VILLAGE OF ORLAND PARK, ILLINOIS

Concrete Deck Installation

ADDENDUM #1 – January 26, 2011

Our office is providing an updated drawing in response to questions by contractors. The proposed membrane topping designation has been added to sheet S-4 of the structural drawing dated January 26, 2011.

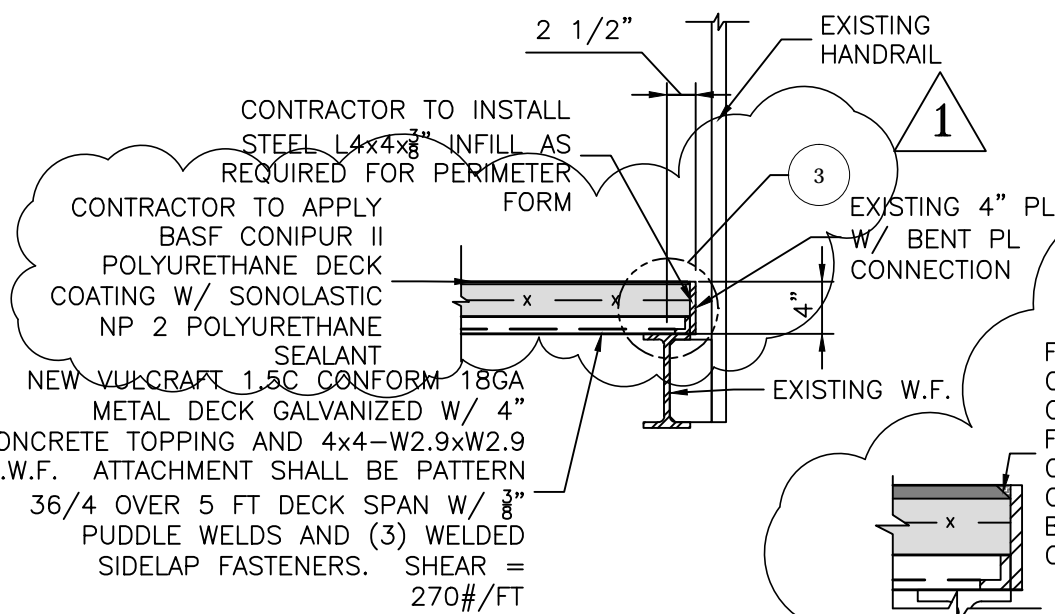
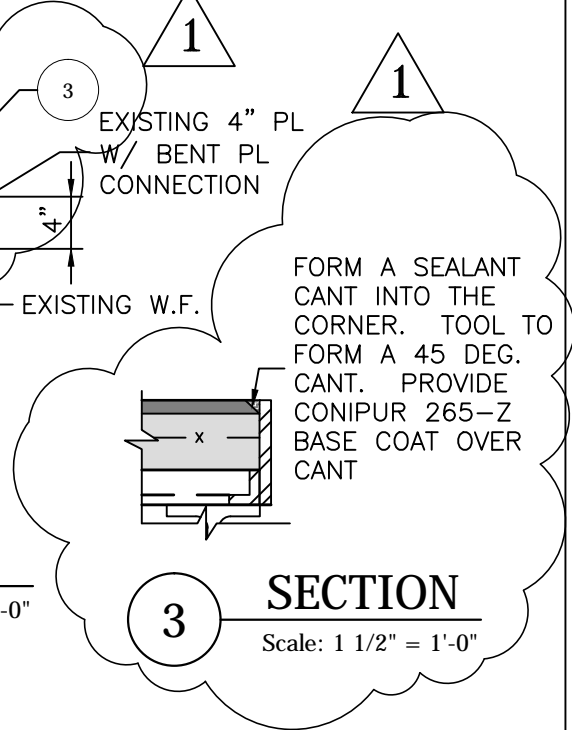
Toppings are polyurethane coatings by BASF. See attached data sheets and structural drawing S-4.
